SERVICE BULLETIN

M1383

2014 TRIKE AND CVO SOFTAIL HYDRAULIC CLUTCH - SAFETY RECALL 0160

Figure 1. Recall Kit 91500069

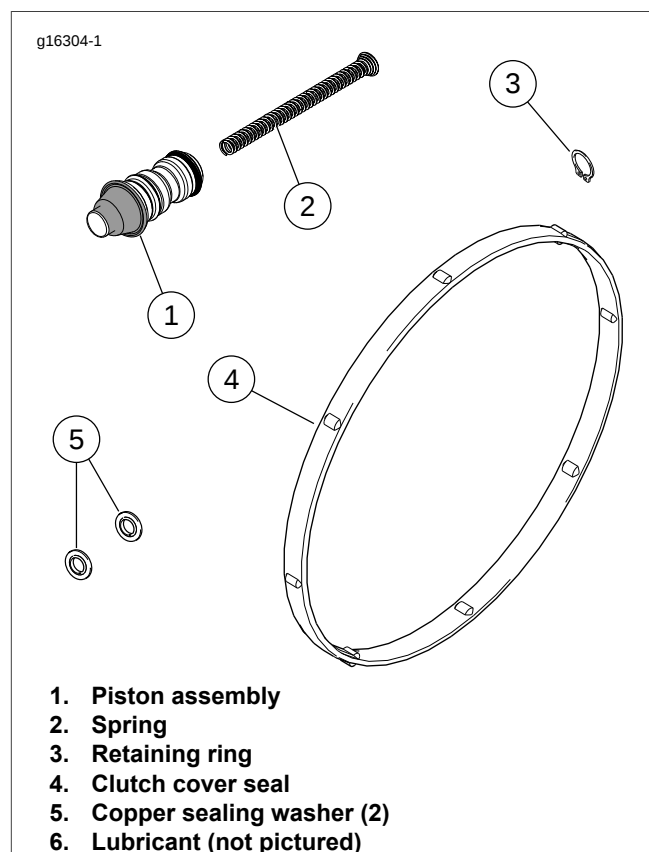
These motorcycles may develop a tear in the primary cup (seal) on the master cylinder piston. If this condition occurs the system may lose the ability to maintain enough lift to keep the clutch disengaged. If this condition remains undetected, it could allow the motorcycle to "creep" forward from a stop, which could lead to a loss of control of the vehicle possibly causing a crash.

Replace Clutch Master Cylinder Piston Assembly

1. Confirm that the motorcycle is involved in Recall 0160.
2. Obtain the recall kit (Part No. 91500069).
3. Replace the clutch master cylinder piston assembly with parts from the recall kit. This kit is to be used on both original equipment clutch master cylinders and chrome accessory clutch master cylinders (Part No. 41700263 and 41700263A). See CLUTCH MASTER CYLINDER AND RESERVOIR in the service manual.
4. Fill and bleed clutch fluid system. See the service manual.
